REVISED RESPONSE TO REQUEST FOR ADDITIONAL INFORMATION

APR1400 Design Certification

Docket No. 52-046

RAI No.: 253-8300
SRP Section: 03.07.01 – Seismic Design Parameters
Application Section: 3.7.1
Date of RAI Issue: 10/19/2015

Figure 5-25 Strain-Compatible Response Spectra at Foundation Level of NI Structures (E-W)

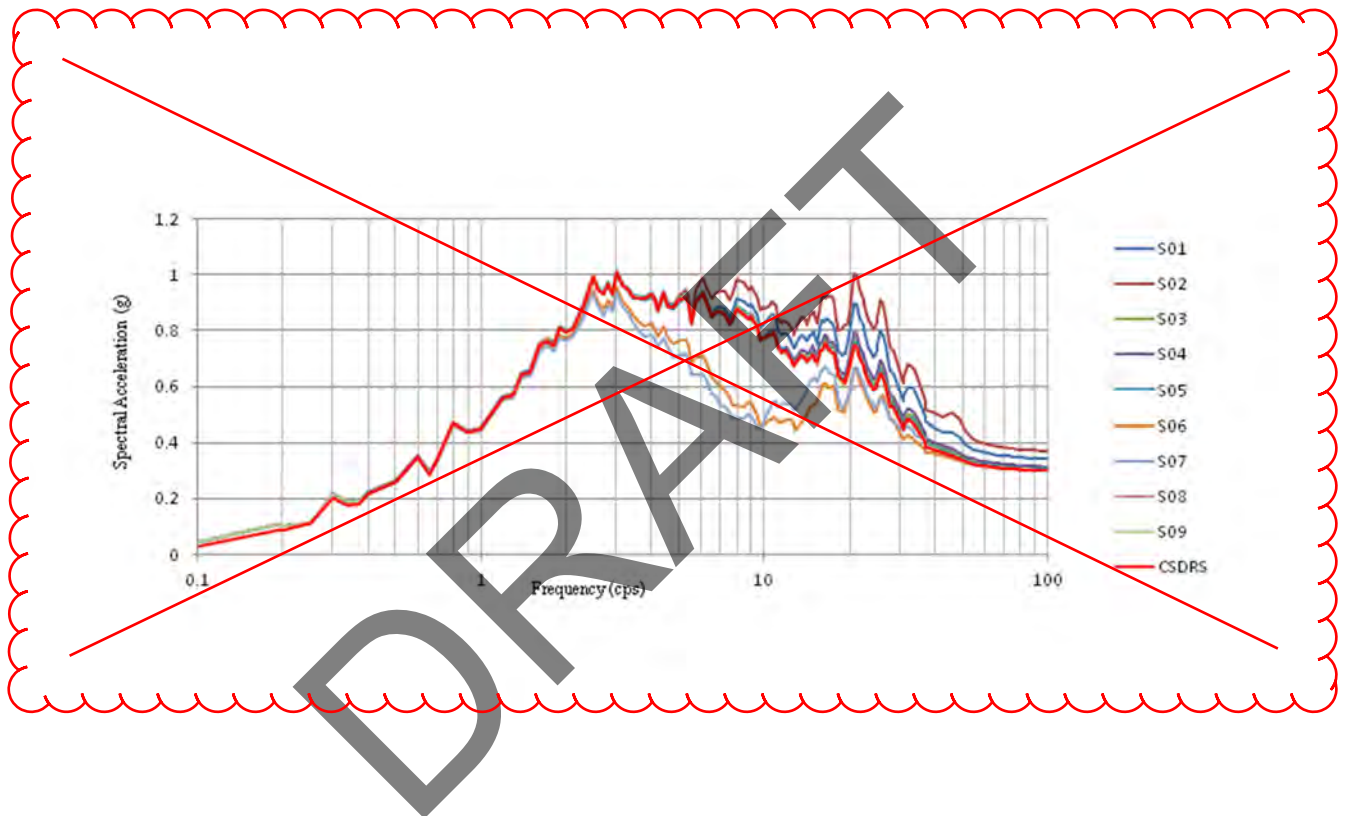
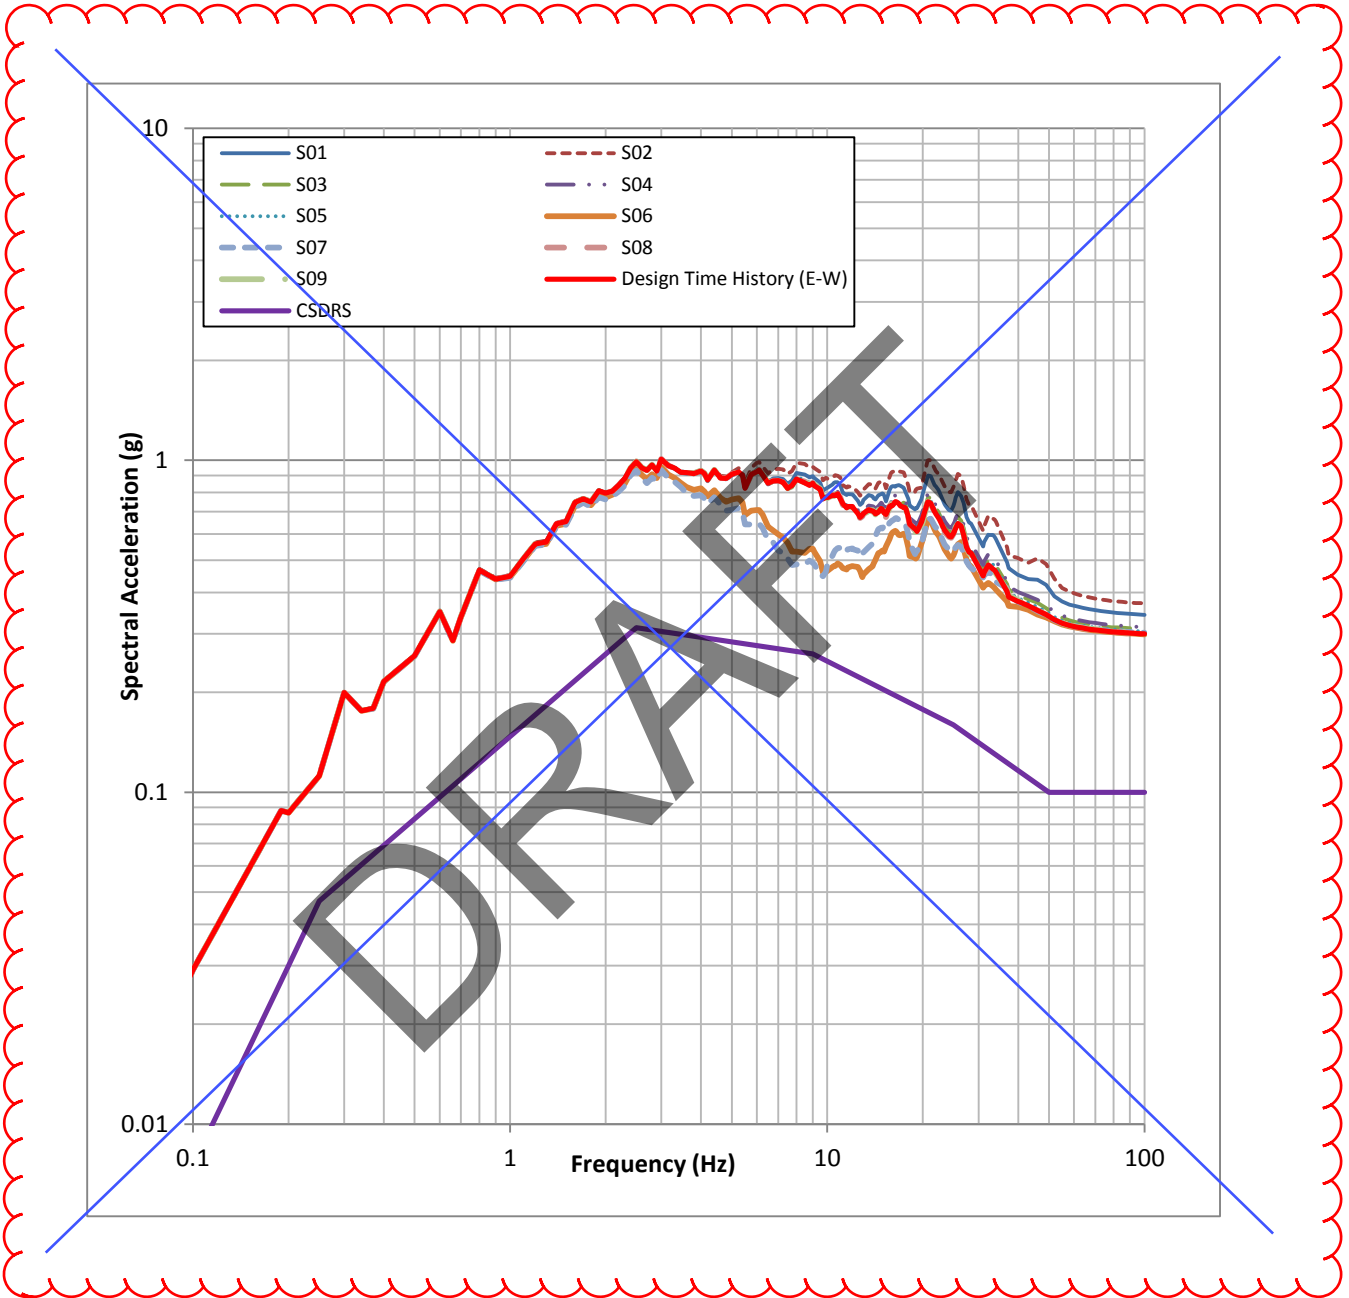
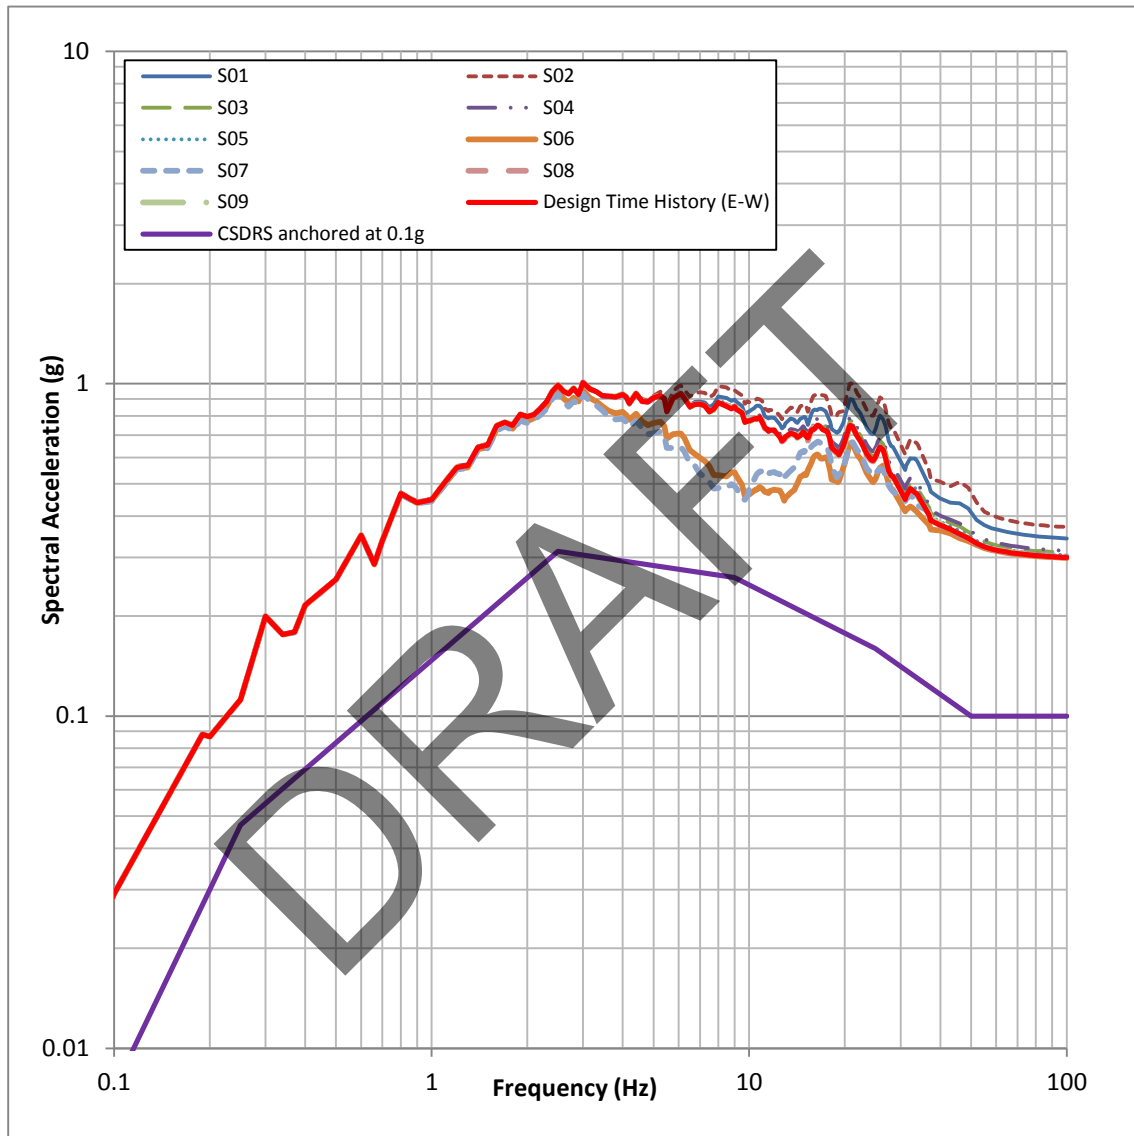
Figures 5-25 and 5-26 of APR1400-E-S-NR-14001-P, Rev. 0 show that the $CSDRS_{ff}$ in the horizontal directions for soil profiles S6 and S7 appear to be significantly different from the other soil cases for the NI structure. Figure 5-27 shows that the $CSDRS_{ff}$ in the vertical direction for these two soil cases are also different but not as significant. The variation in the strain-compatible soil profiles among the 9 layered soil profiles are gradual, as shown in Figures 5-14 through 5-22, and as shown by the approximately linear behavior of the soil fundamental frequency on a log scale in Figure 5-24. The transfer functions shown in Figure 5-23 also indicate that amplification effect occurs at various frequency points below 50 Hz for all soil cases. It is not obvious to the staff why only $CSDRS_{ff}$ for S6 and S7 show the large dips as shown in Figures 5-25 and 5-26 and why other soil profiles for the NI structure (and all soil cases for EDGB and DFOT) do not show any dips at their fundamental frequencies. The applicant is requested to explain in detail (1) the method to calculate the $CSDRS_{ff}$ and (2) why soil cases S6 and S7 for the NI behave differently from the remaining soil cases, and if the results presented in the technical report are not accurate, to include the corrected results for all soil cases, for all 3 structures.

- a) Figures 3.7A-12, 3.7A-13, and 3.7A-14 in DCD Tier 2 and Figures 5-25 through 5-31 in APR1400-E-S-NR-14001-P/NP, Rev.0, "Seismic Design Bases" will be revised as indicated in the attachment associated with this response. The revised figures are presented on a log-log scale. Labels on the revised figures, along with those which have not been changed in the DCD and technical reports, have been reviewed and confirmed to be correct. DCD Tier 2, Section 3.7.6 cites ARP1400-E-S-NR-14001-P/NP, Rev.0, "Seismic Design Bases" as Reference 9.
- b) The $CSDRS_{ff}$ is generated from outcrop motions using the SHAKE91 program. The outcrop motions are calculated at the foundation elevation of each building. The procedure described in the NEI white paper, "Consistent Site-Response/Soil-Structure Interaction Analysis and Evaluation," (June 12, 2009) was followed to produce the results.

The large dips for the S6 and S7 soil cases for the NI are due to the specific site layering configurations and site properties of the S6 and S7 profiles. These large dips are reflected in the site response transfer functions of the motions at the FIRS elevations of the NI structures, DFOT, and EDGB relative to their corresponding free-field surface motions, as indicated in Figures 1 through 18.
